Kenaitze Estates Subdivision 2025 Replat; KPB File 2025-017R1 McLane Consulting Group / Johnson Location: King Salmon Avenue

ITEM #5 - PRELIMINARY PLAT KENAITZE ESTATES SUBDIVISION 2025 REPLAT

KPB File No.	2025-017R1	
Plat Committee Meeting:	April 25, 2025	
Applicant / Owner:	Alan Johnson & Catherine Conklin Johnson / North Plains, OR and	
	Brent Johnson / Tualatin, OR	
Surveyor:	Andrew Hamilton McLane Consulting, Inc.	
General Location:	Funny River area, / Funny River APC

KPB File 2025-017R1 4/7/2025

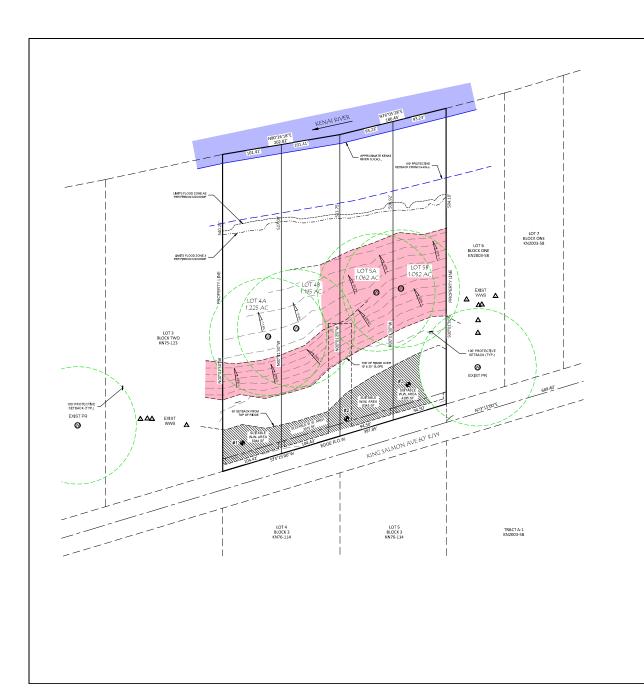
The notes as shown in KPB 20.30.280 D and E are included in plat notes, but should be modified to include the titles from the subcodes in 20.30.280. Also, to be included in plat note 2 should be the FEMA FIRM Panel and flood zones as noted by the River Center reviewer. Limits of the flood zones need to be identified on the drawing.

The River Center review also noted the plat to be located in a habitat protection district. The 50' habitat protection line should be shown on the drawing. Plat note 8 should included the title of the notice as given in KPB 20.30.290.

Need to carry over plat note 1 from the parent plat to this plat.

In the individual Certificate of Ownership and Dedications, the lots indicated need to be corrected to the parent lots. In the Plat Approval, add the date of April 28, 2025

Modify the KPB File No to 2025-017

Legal description needs to be modified as the lot is also in the NE1/4 of Section 23.

Put the correct section numbers on vicinity map.

Add reference to the MHW along the Kenai River or note that the line indicate is the record meander per KN75-123 as noted in plat note 3, whichever should apply.

Add lot label to the southwest

Riverine area according to KWF Wetlands Assessment needs shown

Add Block 2 label to the lot labels on the plat.
